Comhairle Chontae Atha Cliath Theas

PR/0478/23

Record of Executive Business and Chief Executive's Order

Reg. Reference: SDZ22A/0010 **Application Date:** 04-Jul-2022
Submission Type: Significant **Registration Date:** 03-Apr-2023
Additional
Information

Figure 2 roads and junction layout from SDZ

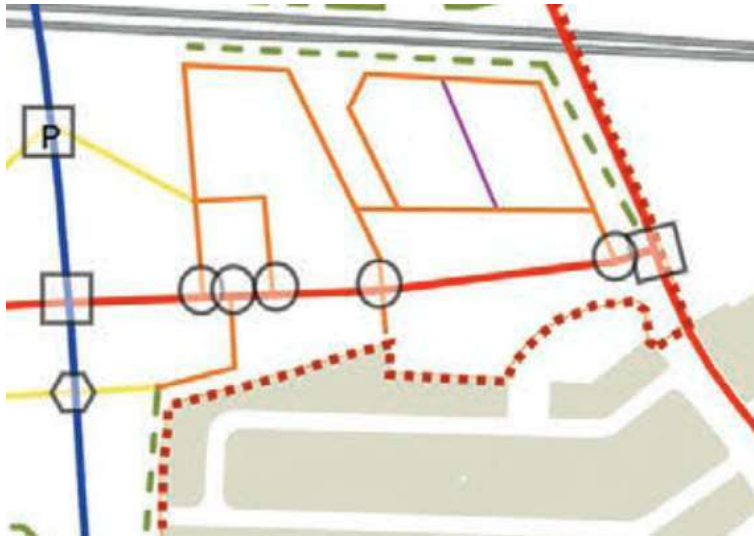
Access & Roads Layout: The roads layout is somewhat like the SDZ, there is a link road missing across the middle section. The number of junctions onto the main east-west link road (SDZ20A/0021) correspond to the proposed layout.

The overall permeability matches the SDZ planning scheme, a pedestrian/cycle link to the train station at Fonthill should be provided in the north-west of the development to match the planning scheme (towards the P in Figure 2)

Figure 7 road cross sections.

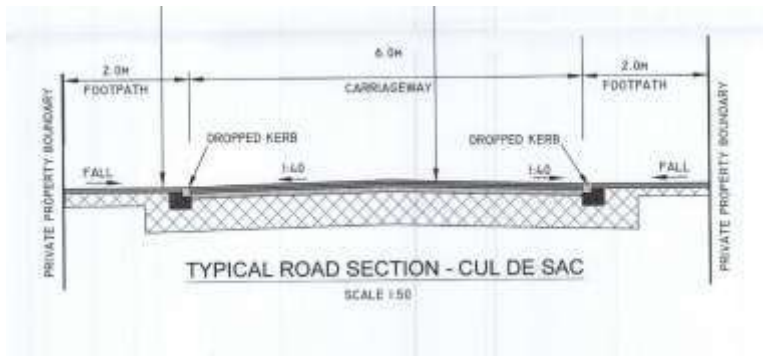
The applicant has provided road cross section details, the details refer to "Cul De Sac" they should refer to the road types identified in the road's layout plan, i.e., Homezone, Link Road etc. and should match the dimensions overall widths and parking arrangements of the road types provided in the SDZ planning scheme.

Figure 2.2.6 | Example Local Streets including Intimate (Intimate Streets)

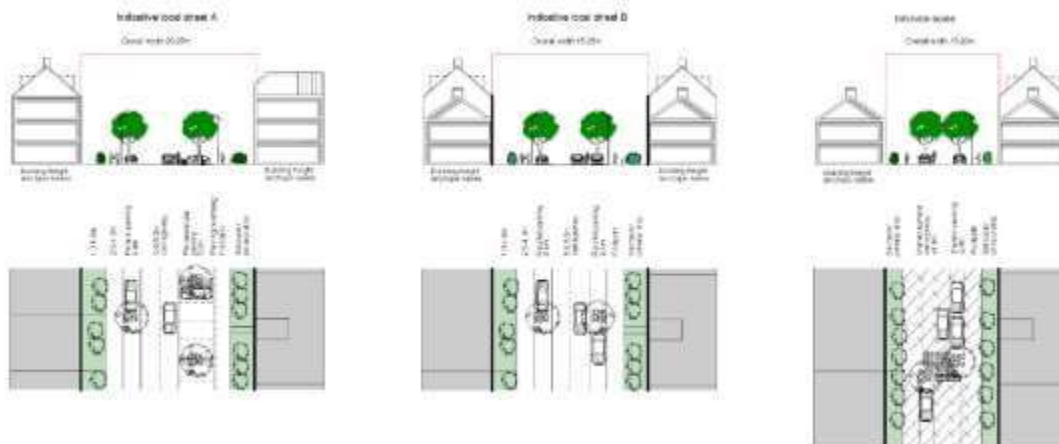
The proposed overall street widths are largely in line with the Planning Scheme. However, the Planning Authority does have concerns in relation to the allocation of space within these, particularly the Local Streets and Intimate Local Streets. Reference is made to Figure 2.2.6 in the Planning Scheme.

The Planning Authority has concerns about the level of perpendicular car parking on the local streets and the on curtilage parking in intimate local streets. The footpaths on the local street are approx. 2m when they should be 2.5-4.0m. Intimate Local Streets should be fully shared surfaces for the integrated movement of vehicles, pedestrians, and cyclists in quieter residential areas. The intimate local street in the east of the site should be significantly redesigned in line with the Planning Scheme. The applicant is requested to submit revised plans indicating revised details via **additional information**. Cross sections should also be provided.

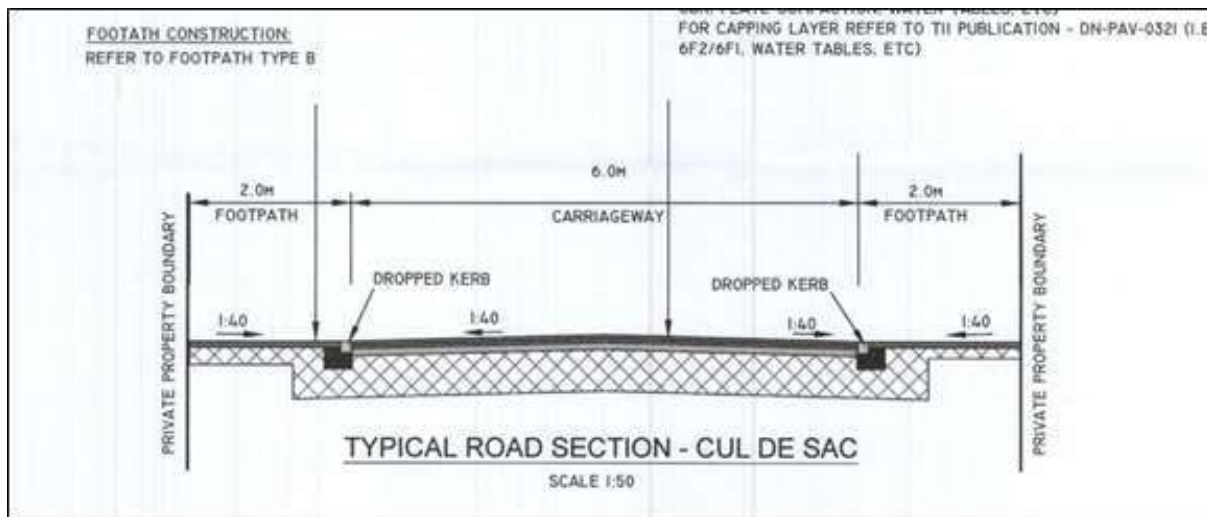
(d) The Planning Authority and Roads Department still have significant concerns in relation to the designation and design of the street network and types. The proposed development includes Intimate Local Streets/Homezones where they are not included in the Planning Scheme. The only Intimate Local Street/Homezone within the subject site, as

indicated in Figure 2.2.7 in the Planning Scheme, is located in the centre north of sub-sector CSE-S1. Any other Intimate Local Streets/Homezones outside of this should be redesigned as Local Streets, as designated under the Planning Scheme. Given the location of the east-west local street along the north of CSE-S1 this should be designed with a fully shared surface for the integrated movement of vehicles, pedestrians and cyclists.
